MODIFICATION No.: 23191K2776

TITLE: AIR CONDITIONING - DISTRIBUTION - INSTALL DRAINAGE DEVICES ON CABIN

SERVICE BULLETIN No.: A320-21-1061

Location of Duct Assys Figure 1, Sheet 1 of 4

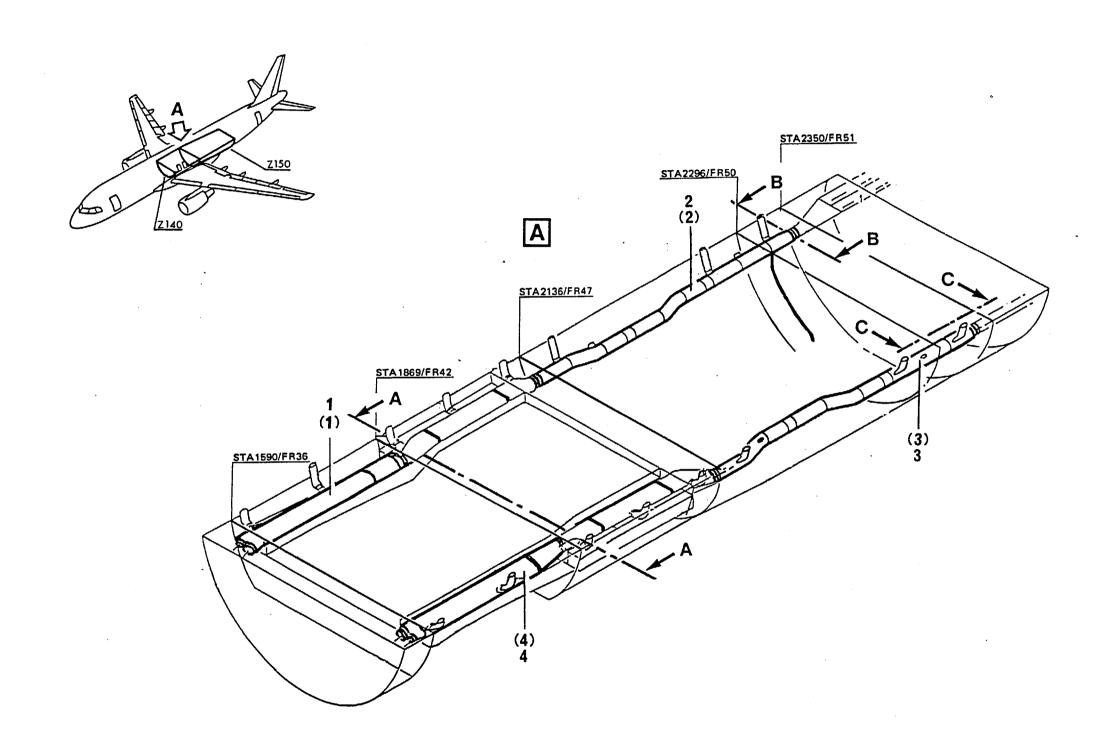
- (a) Removal of the duct assys.
 - 1 Transfer the dimensions to the duct insulation, item 5 and 12, of the duct assys, item (2) and (3) as shown in detail E and section C-C.
 - 2 Mark the existing duct assy position for easy and correct reinstallation.
 - 3 Remove and retain the clamps from the duct assys to be removed.
 - 4 Move the flexible sleeves on the duct assys to disengage the duct assys, item (1), (2), (3) and (4).
 - 5 Remove the duct assys, item (1), (2), (3) and (4) for modification on bench.
- (b) Installation of the duct assys.
 - 1 Make sure that the clamps and the flexible sleeves are in a good condition. Replace, if necessary.
 - 2 Put these duct assys in the installation position as shown in detail A:

Modification of Duct Assys between FR36 and FR42, LH and RH Figure 1, Sheet 2 of 4

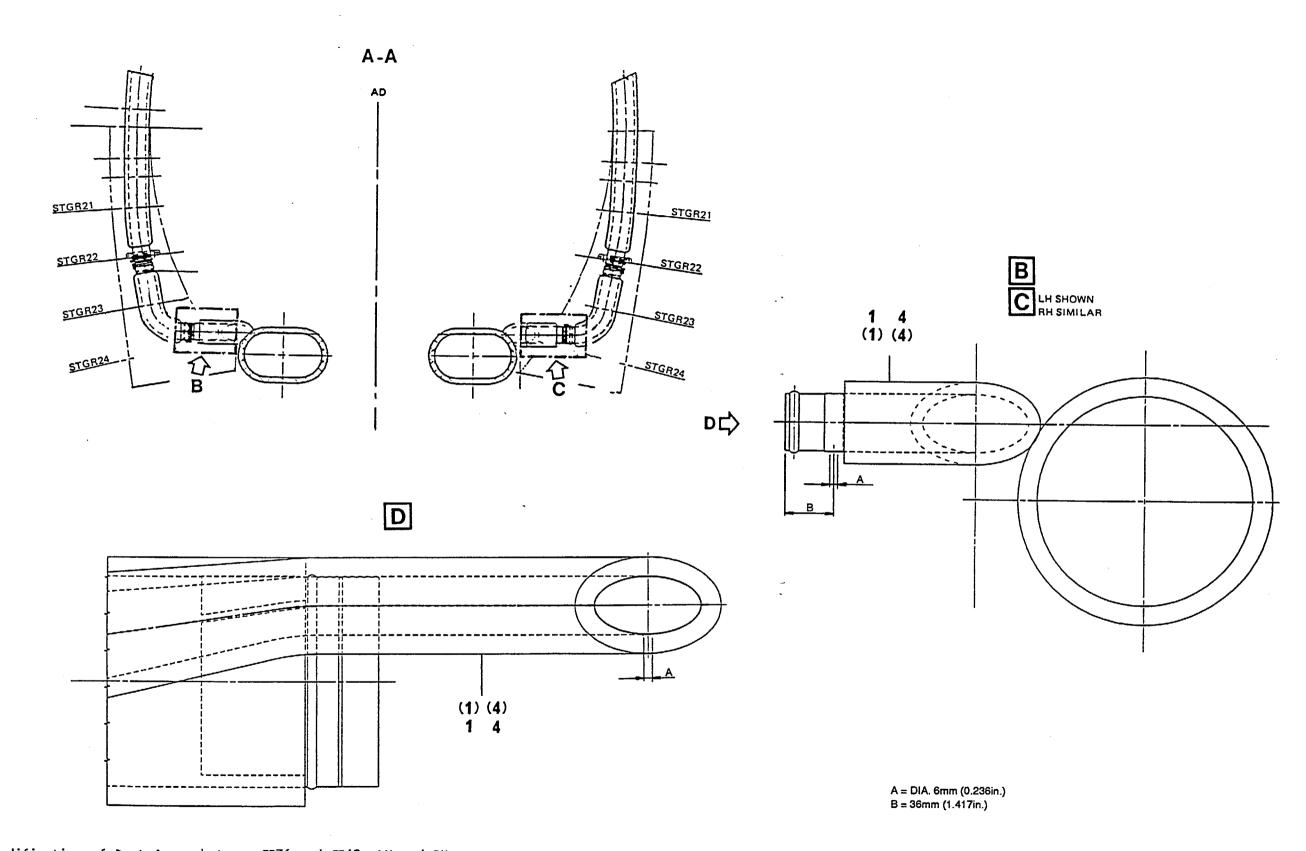
- 3 Move the flexible sleeves to engage the duct assys, item 1, 2, 3 and 4 and install the retained clamps.
- 4 Do not tighten the clamps at this stage.
- 5 Make sure that the duct assys, item 1, 2, 3 and 4 are correctly aligned, than tighten the clamps to the torque value which is indicated on the clamp.
- (2) Installation of the drainage tube

Removal/Installation of Duct Assy between FR47 and FR51 RH Figure 1, Sheet 3 of 4

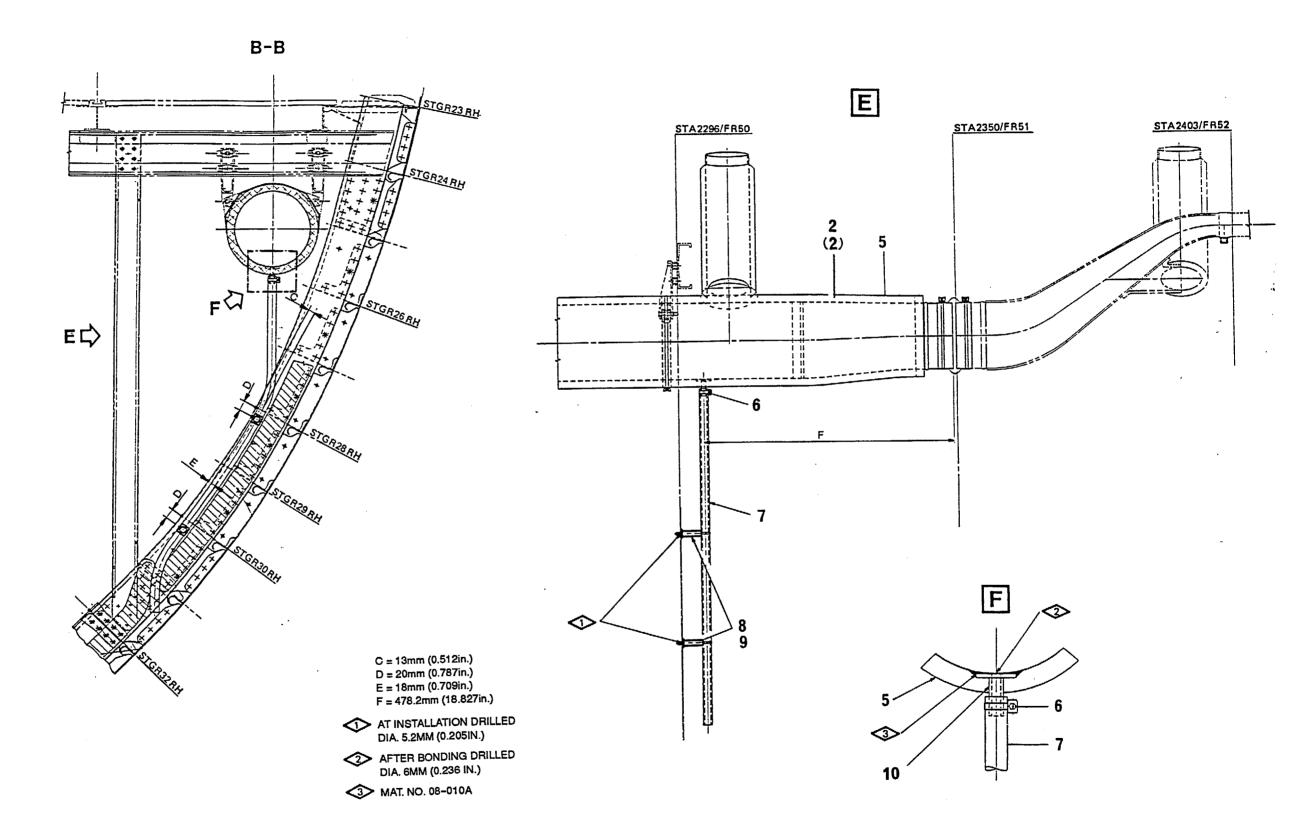
- (a) Transfer dimension for fastening holes as shown in section B-B.
- (b) At FR 50 drill and deburr fastening holes 5.2mm (0.205in.) dia.to dimensions as given in section B-B.
- (c) Apply primer (Mat. No. 16-006) and top coat (Mat. No. 16-002) to the fastening holes.
- (d) Install the drainage tube NSA3629-12-17, item 7, with the clamp ASNA0032-022, item 6, to the nipple D2127115920000, item 10.
- (e) Install the drainage tube, item 7, with mounts NSA935513-05, item 8, and ties NSA935401-03, item 9, to the fastening holes at FR50 as shown in section B-B.
- (f) Put the end of the drainage tube under the insulation mat as shown in section B-B.

Modification of Duct Assy Figure 2

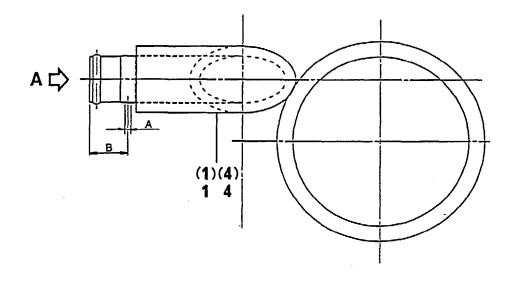
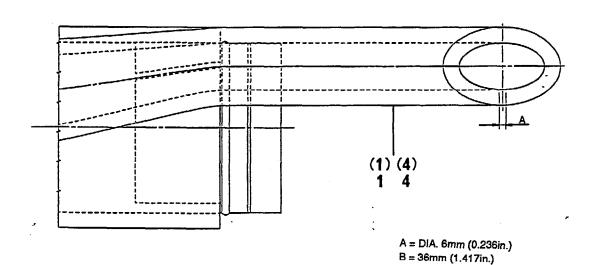
- (a) Drill and debur a hole of dia. 6mm (0.236in.) in the ducts item (1) and (4) to dimension as shown in detail A.
- (b) Re-identify the modified ducts as:

Item	(1)	D2127101400100	becomes	item 1	D2127101403100
		or			
		D2127101400400	becomes		D2127101403400
		or			
		D2127101400700	becomes		D2127101403700
		or	,		
		D2127101400800	becomes		D2127101403800

Item (4) D2127101400200 becomes item 4 D2127101403200

Modification of Duct Assy RH between FR47 and FR51 Figure 3

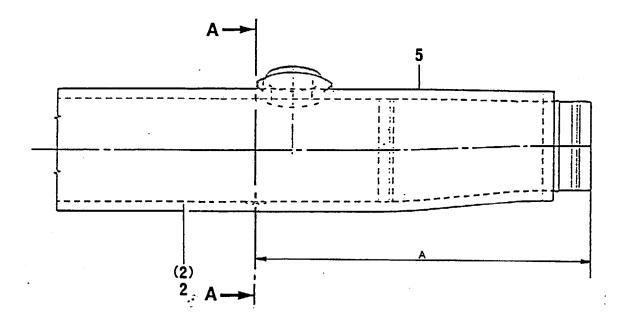
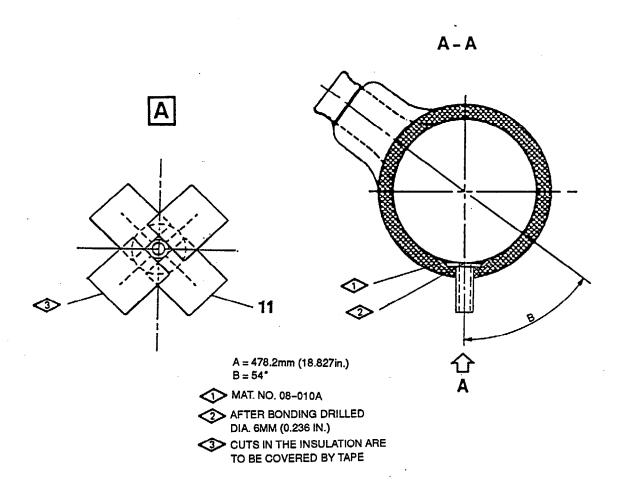
- (a) Remove the duct insulation, item 5, from the duct, item 2, as necessary for modification.
- (b) Install the nipple D2127115920000, item 10, with adhesive Mat. No. 08-010A onto the duct, item (2) to dimension as shown in section A-A.

- (c) After the curing time, drill a hole of dia. 6mm (0.236in.) through the nipple, item 10 in the duct, item (2).
- (d) Cut cross-wise into the duct insulation, item 5, marked in para. 2. B.(1)(a)1 to engage the nipple, item 10.
- (e) Install the duct insulation, item 5, to the modified duct, item 2.
- (f) Cover the cuts with tape D2181000120100, item 11, as shown in detail A.
- (g) Re-identify the modified duct as:

Item (2) D2127102400200 becomes item 2 D2127102406200

Modification of Duct Assy LH between FR47 and FR51 Figure 4

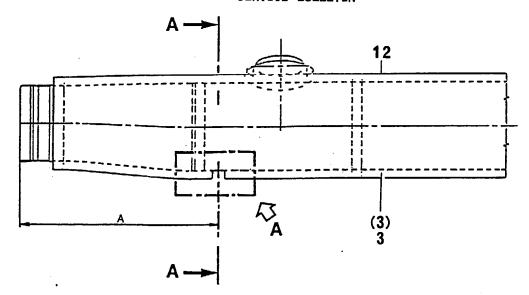
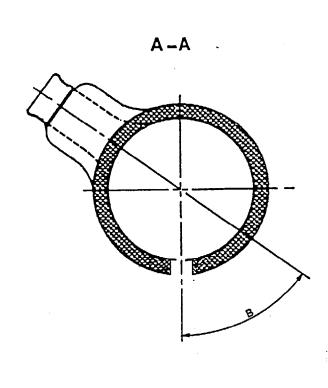
- (a) Remove the duct insulation, item 12, from the duct, item 3, as necessary for modification
- (b) Cut a hole of dia. 40mm (1.575in.) in the duct insulation, item 12, marked in para. 2. B.(1)(a)1 to dimension as shown in detail A.

- (c) Drill and deburr a hole of dia. 6mm (0.236in.) in the duct, item (3) to dimension as shown in detail A.
- (d) Install the duct insulation, item 12, to the modified duct, item 3.
- (e) Reinforce the hole in the duct insulation, item 12, with tape D2181000120100, item 11, as shown in detail A.
- (f) Re-identify the modified duct assy as:

Item (3) D2127102400000 becomes item 3 D2127102406000
